INCH-POUND
MIL-PRF-49471/10A(CR)
AMENDMENT 2
25 April 2002
SUPERSEDING
AMENDMENT 1
15 December 2000

PERFORMANCE SPECIFICATION SHEET

BATTERY, NON-RECHARGEABLE, HIGH PERFORMANCE, WATERTIGHT, BA-X112/U

Figure 1. Battery dimensions.

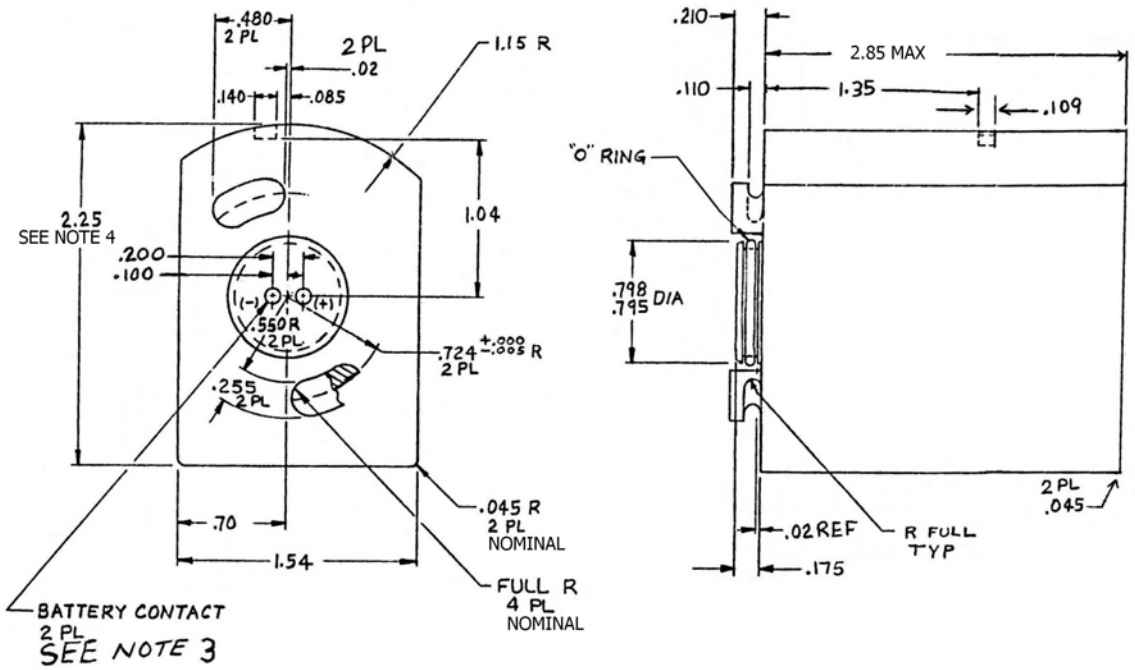
Delete Figure 1 in its entirety and replace with the following:
